Project Name: Randolph BRO 1444(57)

Structure Identification: TH65 (Palmer Road) Bridge 35

The steel bearing shim fabrication drawing associated with Item 531.17, Bearing Device Assembly, Steel Reinforced Elastomeric Pad, has been reviewed and is being returned herewith.

DESCRIPTION: Steel Shim PLs Per Customer Information

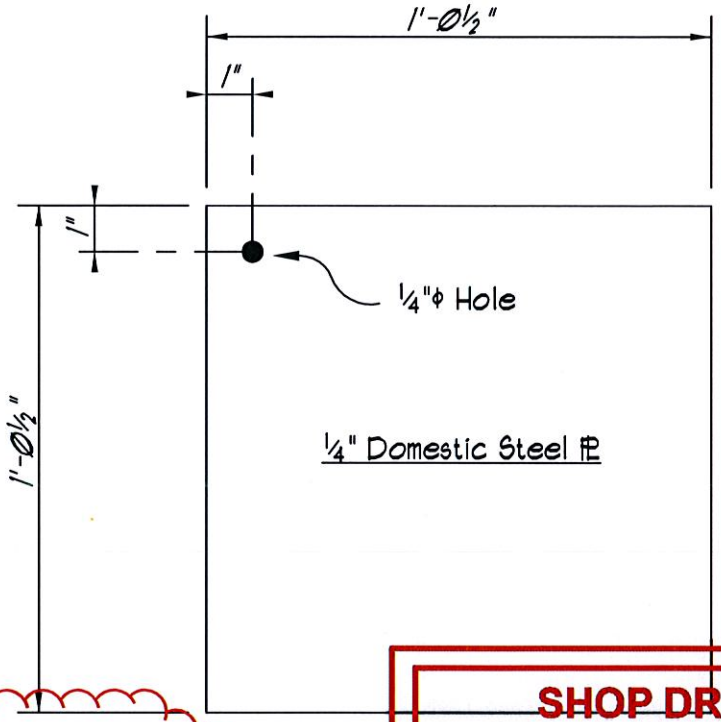
Please specify steel grade. Per specs it should be grade 36 or 50.

Please provide required material certifications.

Please add the following notes:

1. Prior to galvanizing, all corners and edges of steel plates, shapes, etc., shall be ground to a 1/16" (1.6mm) radius.

2. Surfaces to be galvanized shall be zinc coated in conformance with AASHTO M 111M/ M111 or, when applicable, AASHTO M 232M/ M232.

Please specify steel grade. Per specs it should be grade 36 or 50.
